Rezoning Transportation Analysis

Petition Number: 2017-035

General Location Identifier: 119-064-22, 119-064-23, 119-064-30, 119-063-13

New Bern Transit Station Area Plan

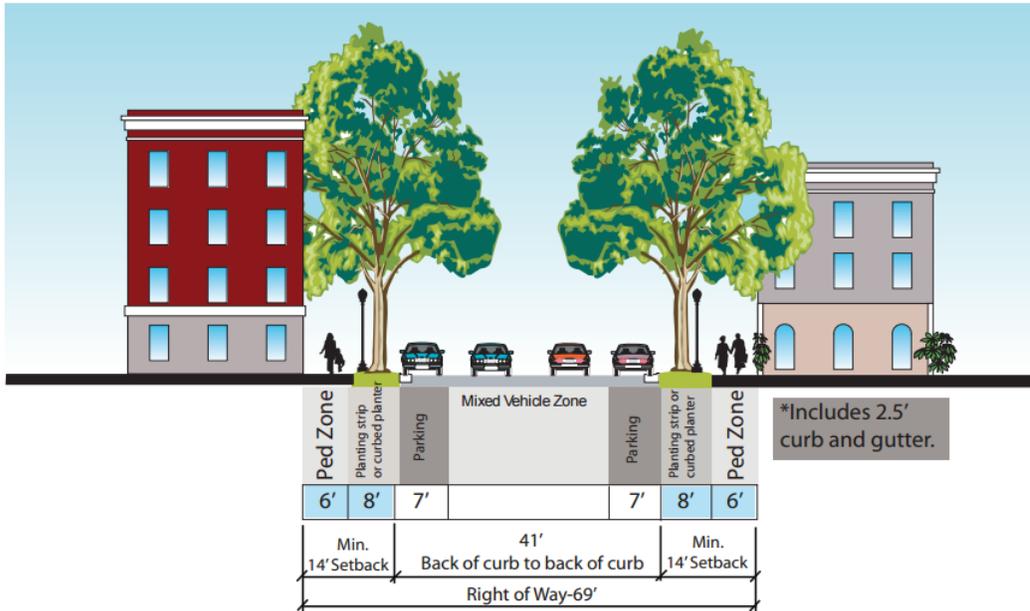
The proposed zoning district has a setback measured from an existing or proposed future curbline. The location of the future curbline per the area plan is 20.50' from existing centerline (see below). However, CDOT is requesting that this curbline take into account a future 7' bike lane. Thus, the future curbline should be placed 27.50' from existing centerline.

1. The petitioner should revise the site plan by relocating the proposed curb 27.50' from the existing centerline of road. This will account for the area plan recommendation in addition to the future bike lane.
